AS CONSTRUCTED PLANS
RETURN TO DIST. 4 DESIGN

AS CONSTRUCTED

INDEX OF SHEETS REVISED DATE 12-21-72

PLAN AND PROFILE OF PROPOSED FEDERAL AID PROJECT NO. U 006-9(2) STATE HIGHWAY NO. 6 LOGAN COUNTY

U006-9 (2)
101
12-21-72

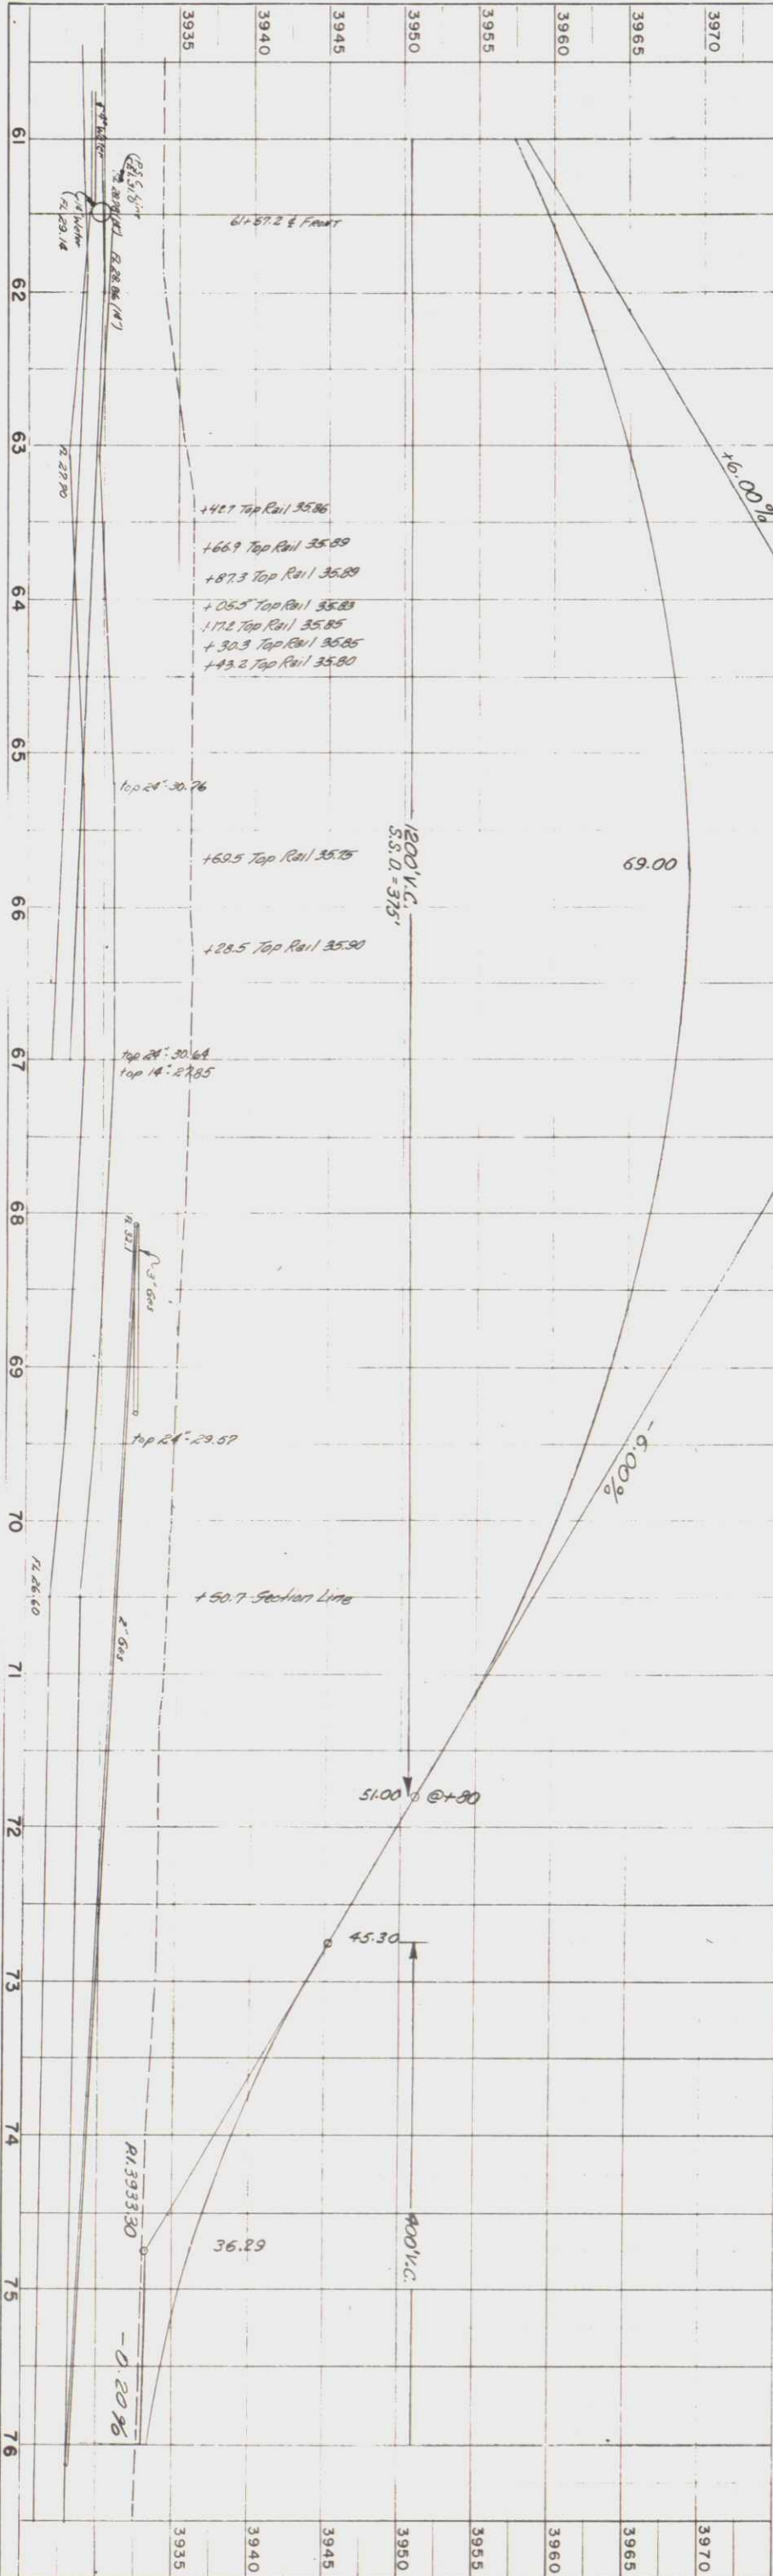
55+48 $\approx$ ~~Proposed~~ Inlet #9, Type 3 Rt. with 15"x38' RCP to Inlet #10
55+48 $\approx$ ~~Proposed~~ Inlet #10, Type 3 Rt. 15"x36" with 15"x48' RCP to existing manhole at 55+20
57+98 $\approx$ ~~Proposed~~ Inlet #7, Type 3 Rt. with 15"x78' RCP to Inlet #5
58+38 $\approx$ ~~Proposed~~ Street Approach Lt. & Rt.
58+78 $\approx$ ~~Proposed~~ Inlet #5, Type 3 Rt. with 15"x130' RCP to Inlet #6
58+ to 61+ $\approx$ ~~Proposed~~ Landscaping in Median Area (Details on Sh. Nos. 18-23)
58+ to 73+ $\approx$ ~~Proposed~~ Overpass Sh. No. B-24-AQ (Details on Sh. Nos. 30-99)
60+04 $\approx$ ~~Proposed~~ Alley Approach Lt. & Rt.

55+ $\approx$ ~~Proposed~~ Traffic Signalization (Details on Sh. Nos. 24-25)
55+20 $\approx$ ~~Proposed~~ Manhole #2, Slab Base, 66' Lt. on existing 36" Storm Sewer
55+48 $\approx$ ~~Proposed~~ Inlet #11, Type 3 Lt. with 15"x34' RCP to Inlet #12
55+48 $\approx$ ~~Proposed~~ Inlet #12, Type 3 Lt. 18"x24" with 18"x48' RCP to Manhole #2 at 55+20
56+74 $\approx$ ~~Proposed~~ Alley Approach Lt. 15"x18' RCP Inlet #12
57+98 $\approx$ ~~Proposed~~ Inlet #8, Type 3 Lt. with 18"x246' RCP to Inlet #12
58+32 $\approx$ ~~Proposed~~ Manhole #1, Slab Base Lt. 18"x32' RCP to Inlet #8, Special Inlet for Bridge Drain Lt. & Rt. (Details Sh. Nos. 65-66) 12" Bit Coated CSP Rundown from Bridge Drains to Manhole #1 (Detail on Sh. No. 14)
58+78 $\approx$ ~~Proposed~~ Inlet #6, Type 3 Lt. with 18"x44' RCP to Manhole #1 at 58+32
